Wood Duck Solar LLC
Responses to Siting Board Staff's Second Request for Information
Case No. 2024-00337

Wood Duck Solar LLC
Responses to Siting Board Staff's Second Request for Information
Case No. 2024-00337

Title
Proposed Screening Plan

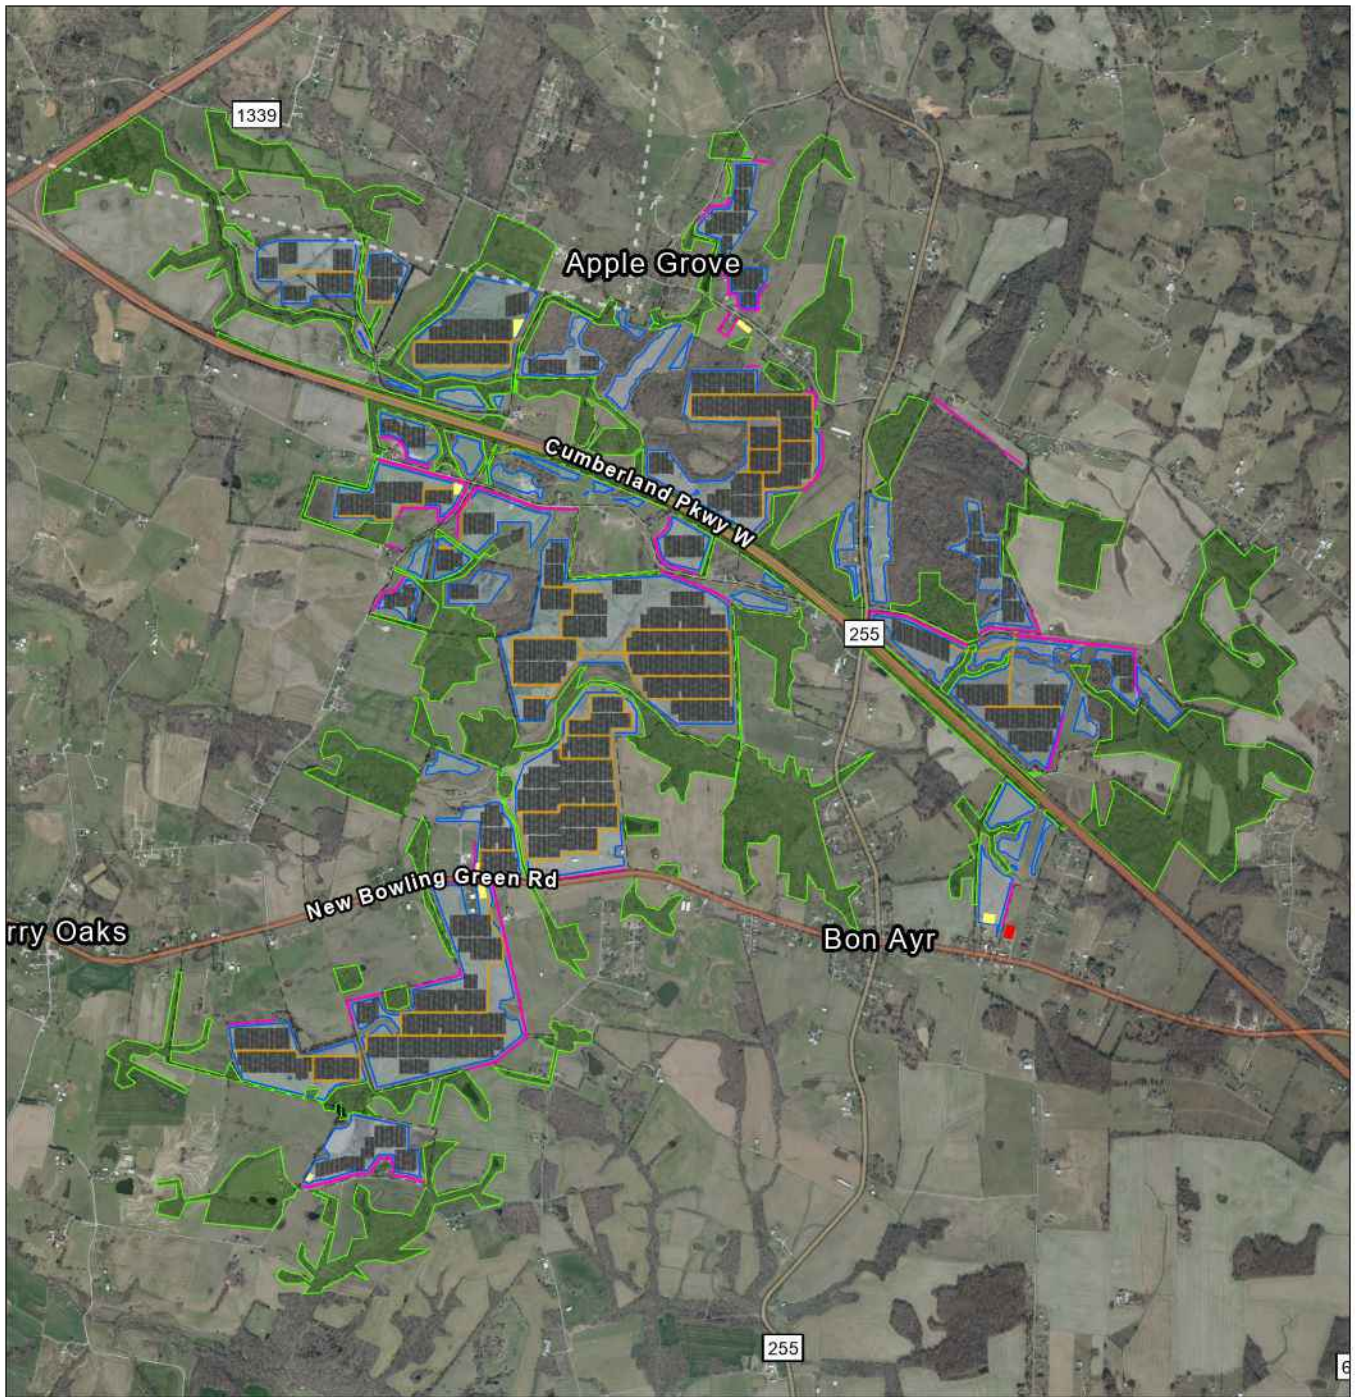
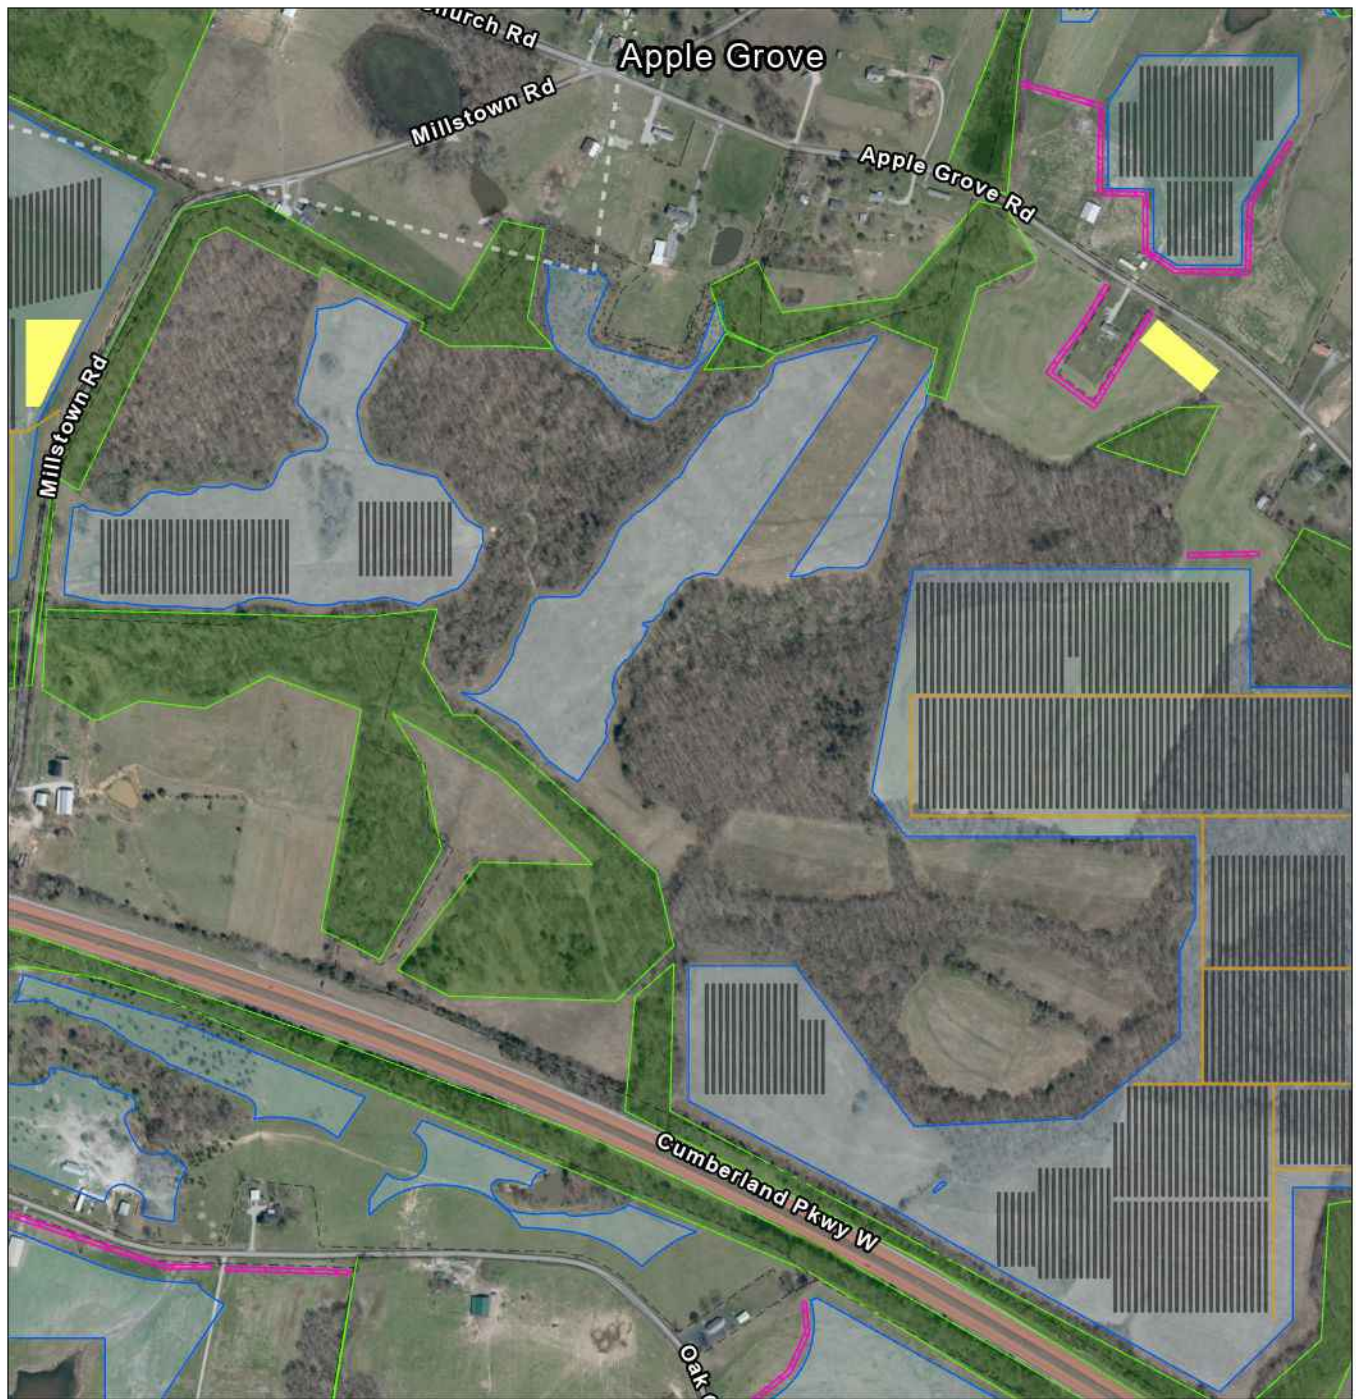
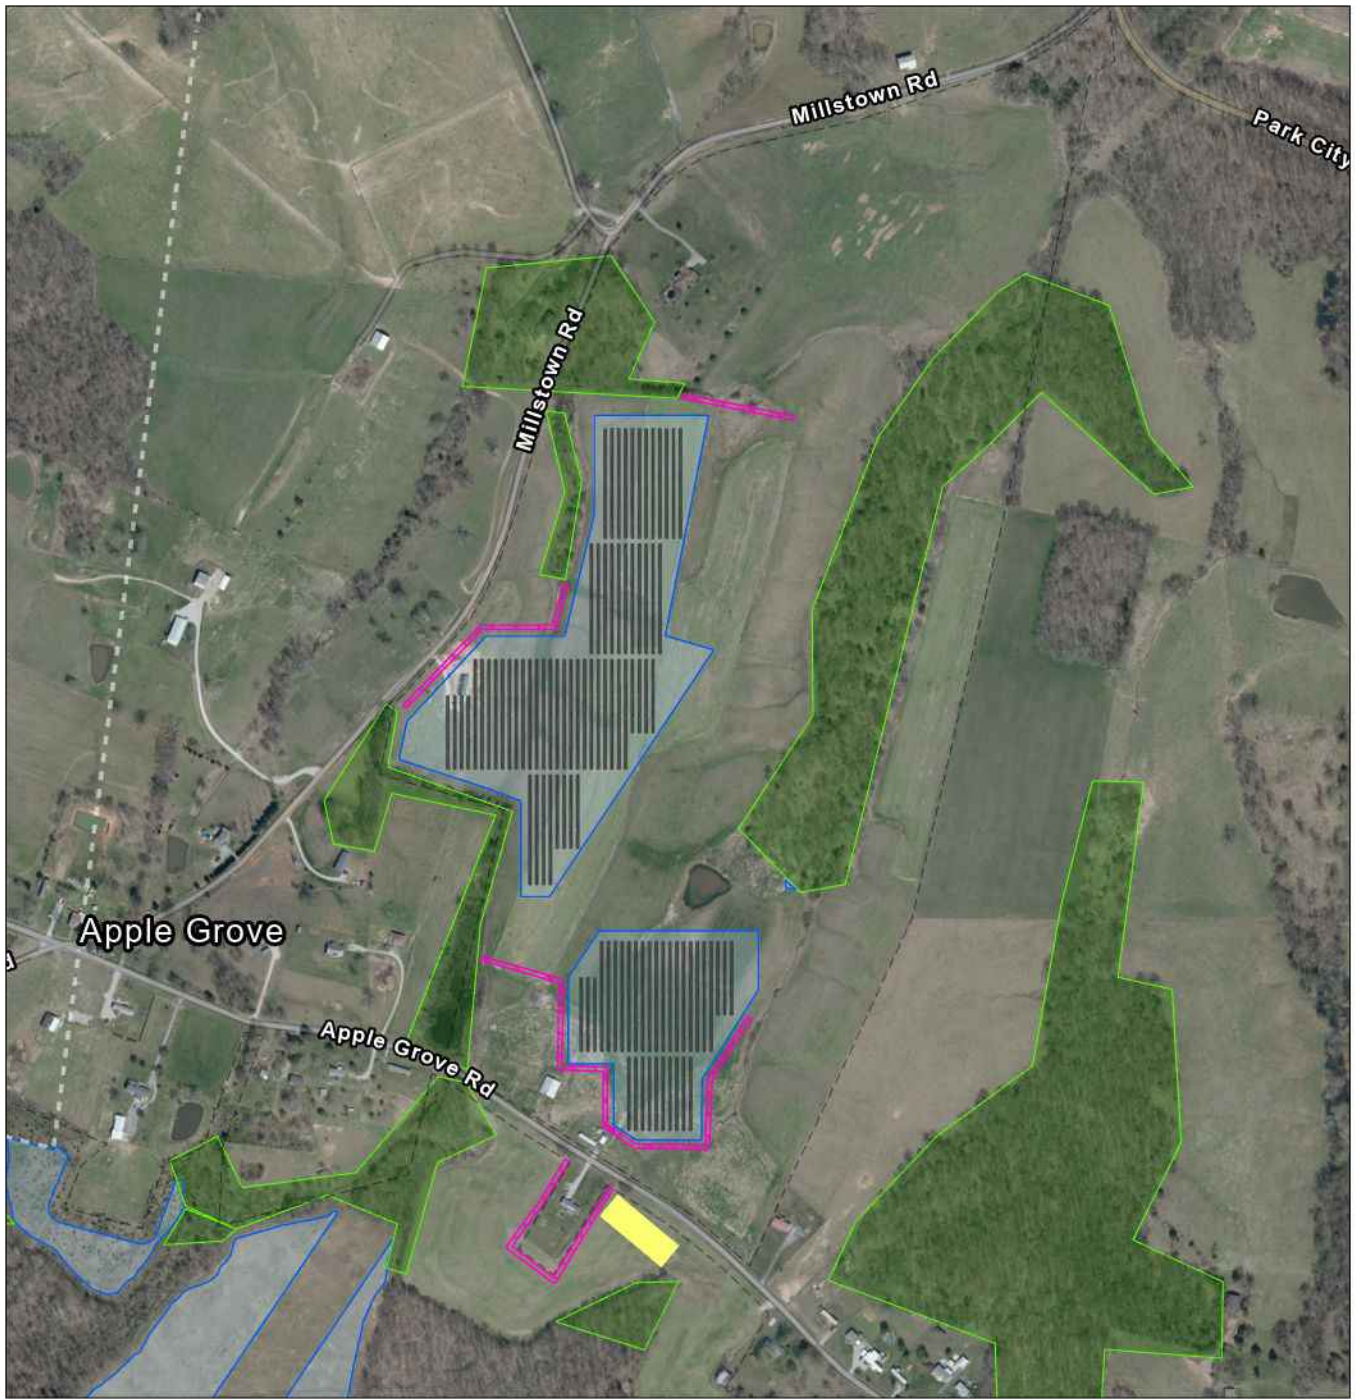
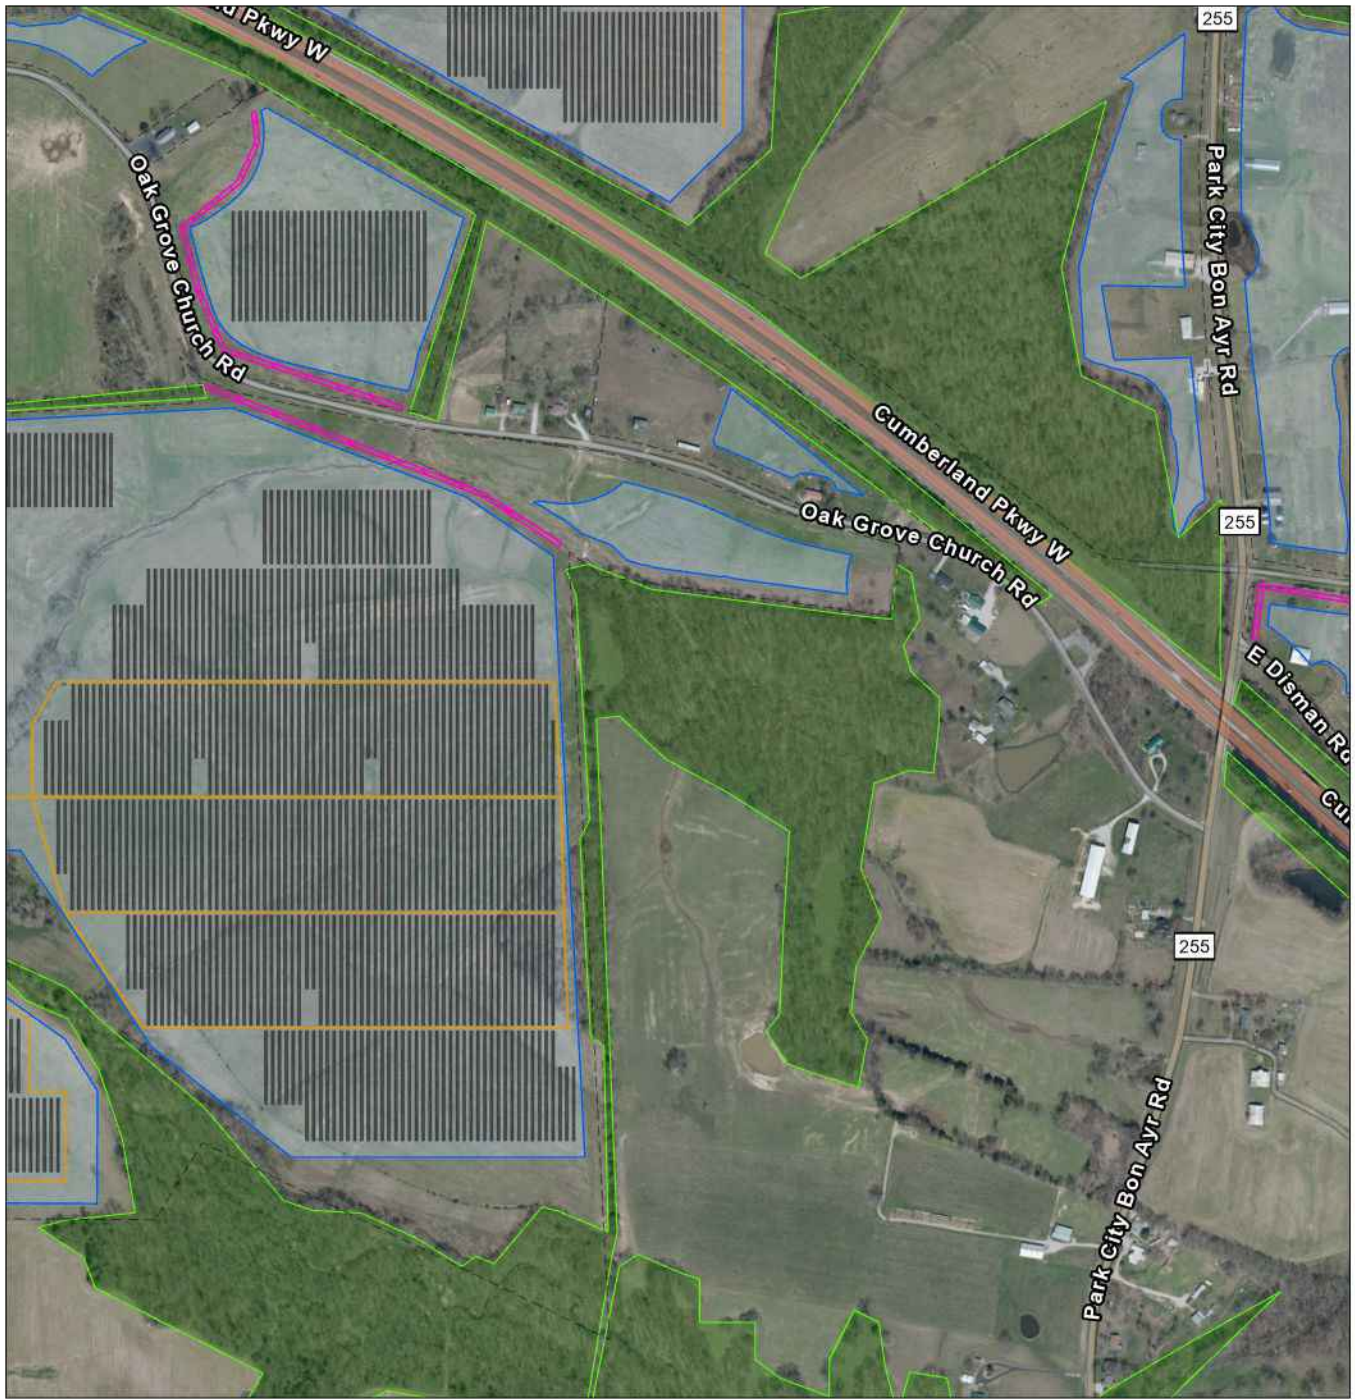
Refer to SAR, Attachment G, Appendix A, C202 Preliminary Landscape Plan map, and site visit. Logging has occurred on parcels where solar module Areas #18 and #21 are proposed and “existing buffer” as marked on the map has diminished. Provide a revised landscaping plan for areas that have been cleared by logging east of Millstown Rd and west of Park City-Bon Ayr Rd.

See attached. The revised landscaping plan was extended to add supplemental screening in areas that had cleared vegetation. The new length of proposed vegetative screening is now 45,353.92 feet (8.60 miles).
